Re: Gort Town Centre Public Realm Enhancement Project, Gort, Co. Galway
In the townlands of Gort, Co. Galway

Submission re ;Gort Town Center Public Realm Enhancement project

Re: Gort Town Centre Public Realm Enhancement Project

3.3.22 Barrack Street – Car Park Disabled users Parking

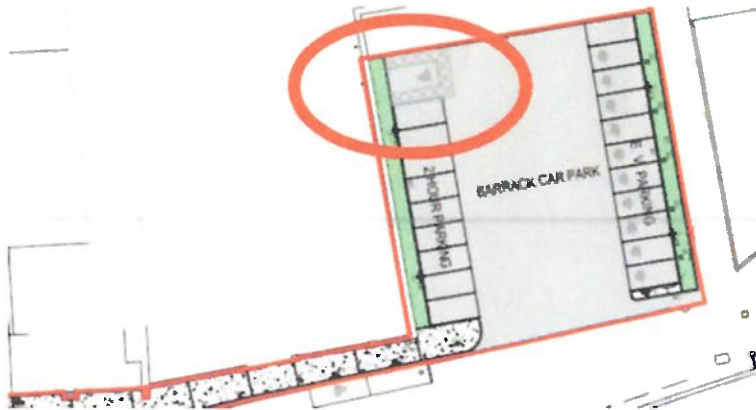
Problem: The disabled user parking space within the car park is not located adject to a segregated footpath. Disabled users will be required to walk through the trafficked area of the car park in order to access the footpath.

Hazard: Impact from passing or reversing vehicles may occur.
